**Part C – Item 4.1a - LOTS 3, 4, 8, 17, 18, 20, 21, 23, 24, 25,
42, 201, 500 ALBANY HIGHWAY, MADDINGTON –
SHOWROOM (BUNNINGS WAREHOUSE)**

**Form 2 – Responsible Authority Report
(Regulation 17)**

DAP Name:	Metro Outer
Local Government Area:	City of Gosnells
Proposed Amendments:	Reduction in building floor area and revised access arrangements.
Applicant:	Mark Scarfone, Element
Owner:	Bunnings Properties Pty Ltd Metropolitan Region Planning Authority Western Australian Planning Commission
Value of Amendment:	\$ 20m
Responsible Authority:	City of Gosnells
Authorising Officer:	Brenton Scambler – Manager Development Services
LG Reference:	DA18/00283.03
DAP File No:	DAP/18/01540
Date of Original DAP decision:	22 January 2020
Application Received Date:	21 May 2025
Application Statutory Process Timeframe:	90 Days
Attachment(s):	1. Location Plan 2. Development Plans 3. Reserve Interface Plans 4. DBCA Advice 5. PTA Advice 6. DWER Advice 7. MRWA Advice 8. Previous Determination Notices 9. WAPC Amalgamation Approval 10. Cover Letter 11. Consolidated Amended Conditions & Advice Notes

Figure 5.1
Topography &
Classified Vegetation

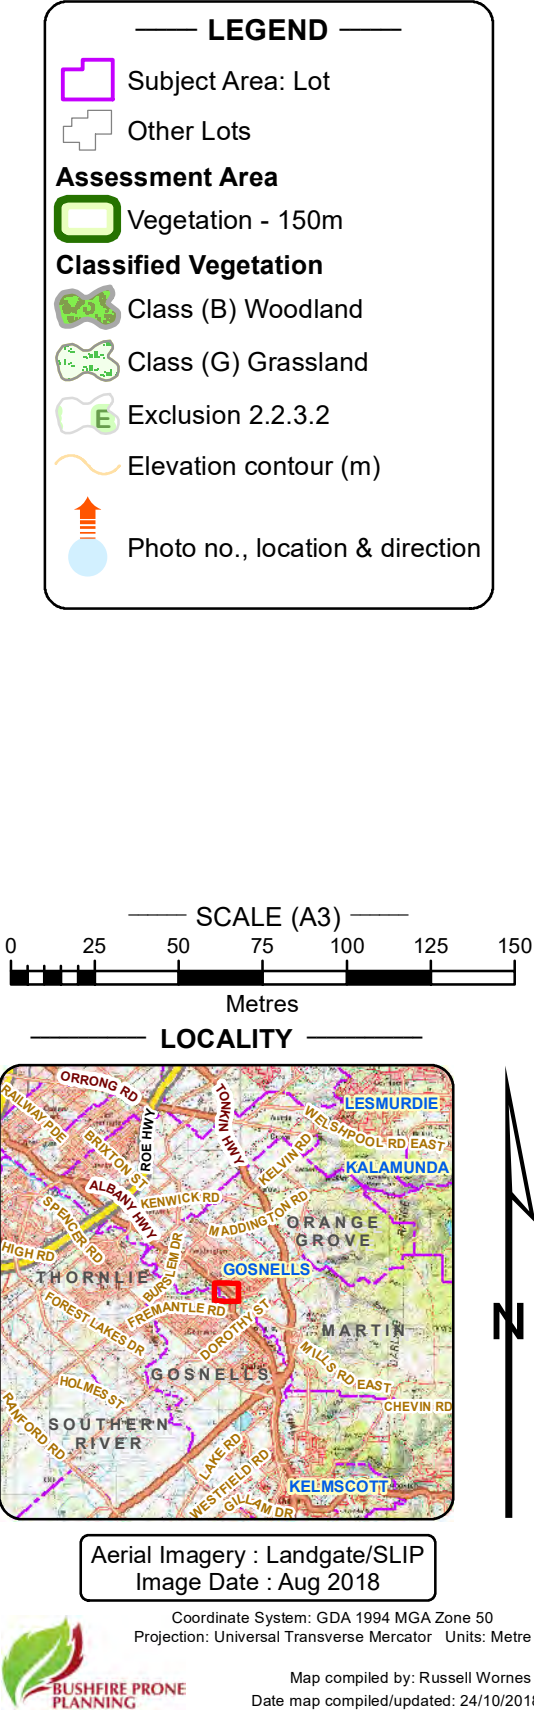
As previously advised, the applicant should also acknowledge that the ROS reserve may be rehabilitated in the future and their Bushfire Management Plan should be updated to reference Class A Forest rather than Class B Woodland in Areas 2 & 3 (see attached plan). In accordance with State Planning Policy 3.7 – Planning in Bushfire Prone Areas, planning proposals should satisfy bushfire protection requirements within the boundaries of the land being developed and not impact on the bushfire and environmental management of neighbouring foreshore reserves. The Regional Open Space abutting the western boundary of the subject lot should be identified as Class A Forest to account for future revegetation within the reserve.

- the proposal is amended to address an updated Bushfire Management Plan (BMP). The BMP shall include a Class A – Forest vegetation classification to the Regional Open Space.
- further detail is provided on the proposed access across Lot 8 and the tie in with the existing access to Lot 5.

MAIN ROADS MARKED-UP PLAN

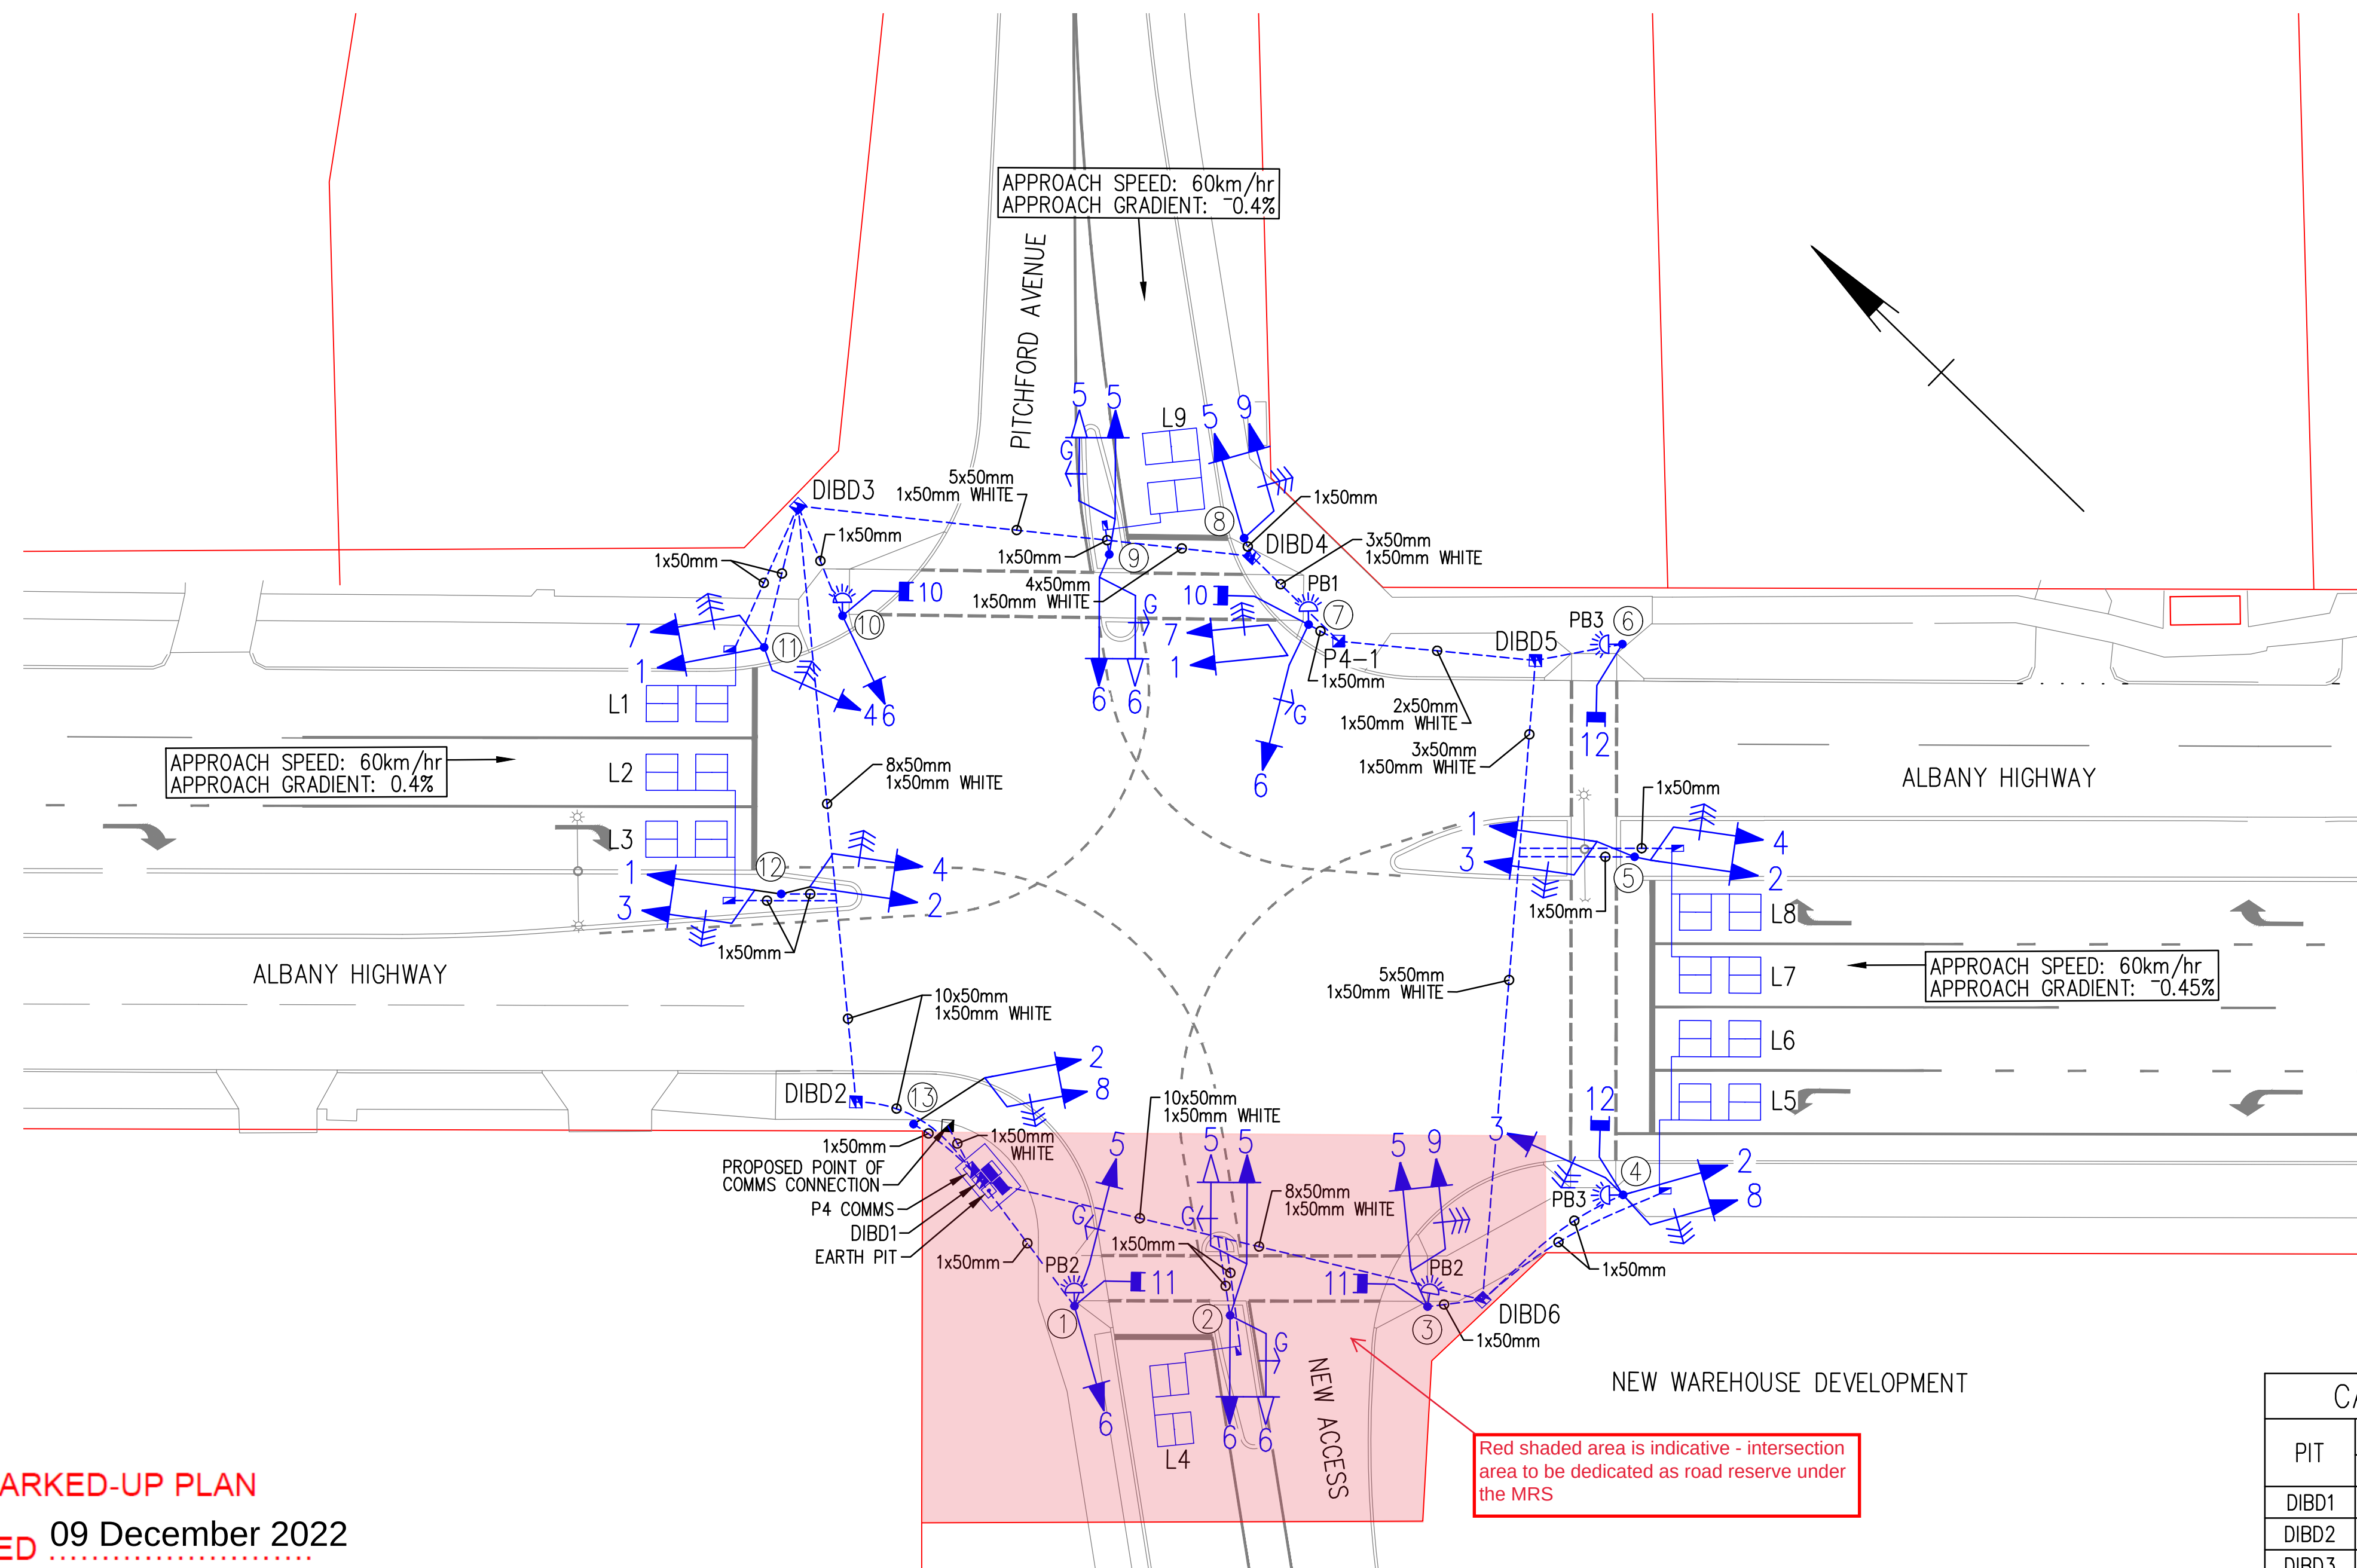
AMENDED IN RED 09 December 2022
